SUBJECT: Forwards responses to NRC 800108 questions re Pond Hill Reservoir.

SUSQUEHANNA STEAM ELECTRIC STATION
POND HILL RESERVOIR INFORMATION REQUEST
ER 100450 PLA-442 FILE 991-2

SUSQUEHANNA SES RESERVOIR STUDY
POND HILL RESERVOIR

COMPARATIVE WATER CONDUIT STUDY
GENERAL PROJECT PLAN

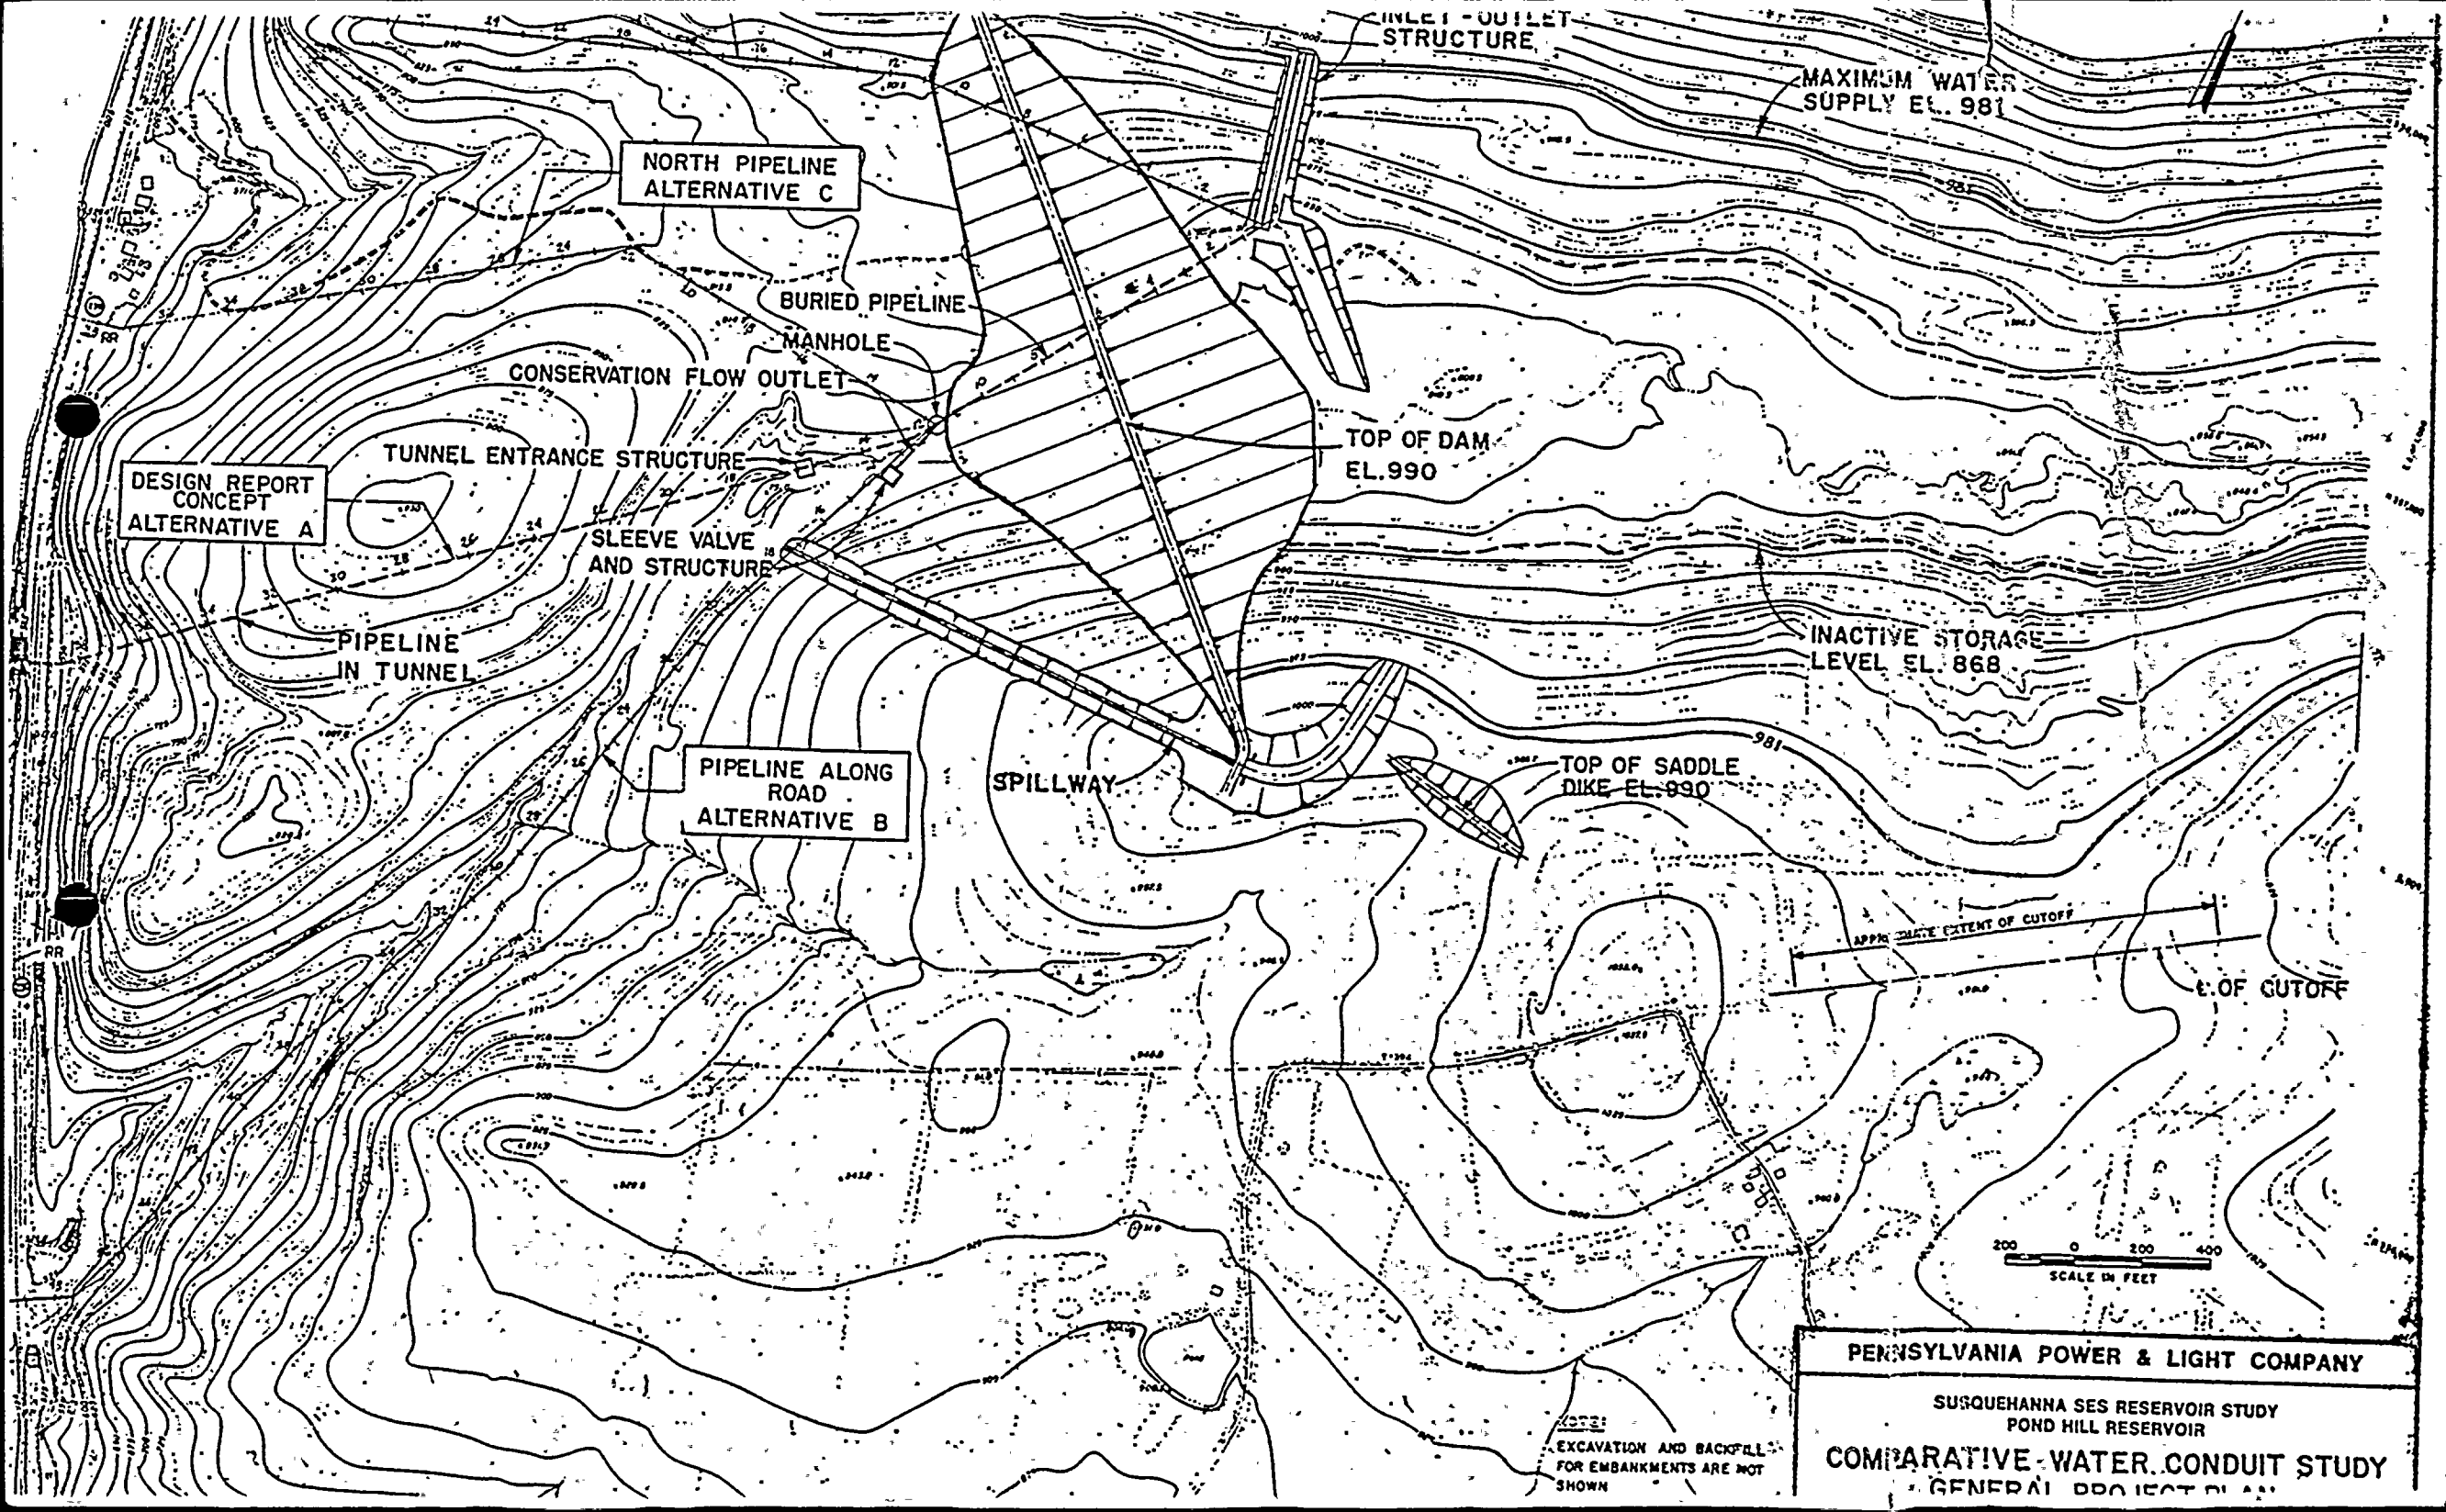
5. Provide additional information on location and construction of the new road and pipeline down to the pumphouse, if available.

5. As indicated in our December 17, 1979 response, the proposed access road will be constructed on the south side of Pond Hill Creek. The road and the pipeline will be built in the same corridor. This route is shown as Alternative B on Plate A-1 which was part of our response. A copy of the Plate is attached. Details of this road will be determined during final design.
